ERRATA TO THE TSB11C01 DATA SHEET

(TEXAS INSTRUMENTS LITERATURE NO. SLLS167A, MARCH 1996)

This document contains corrections and additions to information in the TSB11C01 data sheet (TI Literature Number SLLS167A, March 1996), also included in *IEEE 1394 Circuits Data Book*, 1997 (TI Literature Number SLLD004).

Figure 6. Status Transfer Timing

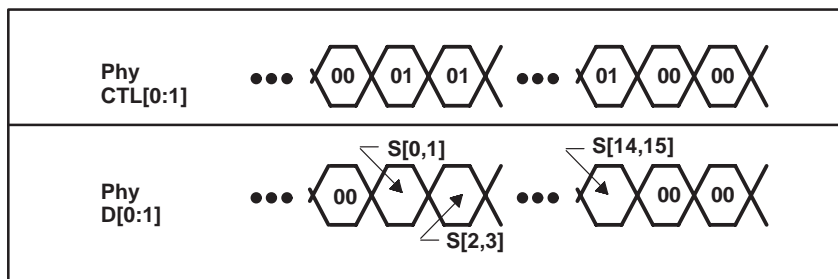
- dd. Replace the transfer timing diagram in Figure 6 (page 16 of the data sheet, page 6–18 of the *IEEE 1394 Circuits Data Book*, 1997) with the following diagram:
